Exhibit No.: 6C

Short title: DEF's Confidential Response to OPC's POD 5, Q22

**Generator, Stator Core Seals, Inspection and
Replacement, SGen5-1000A and SGen6-1000A**

PB3-13-0008-GN-EN-01

Figure 2: Photo of Generator with Upper Frame Removed.

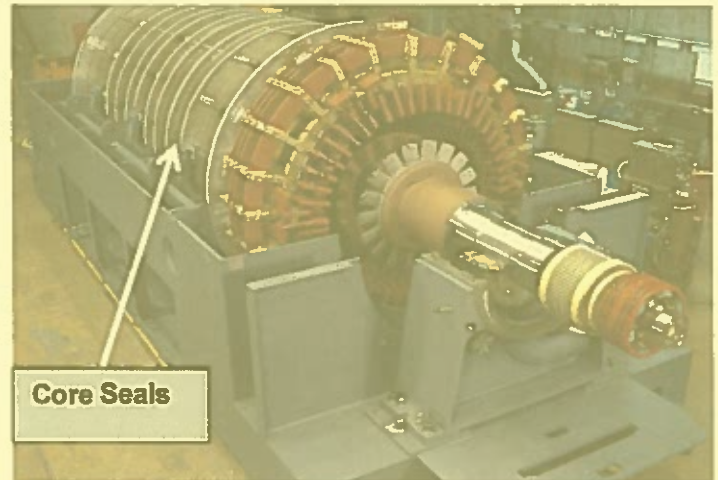
Figures 1 and 2 show the locations of the core seals in relation to the overall generator. The seals are located in 10 places; each seal is 360 degrees around the stator core.
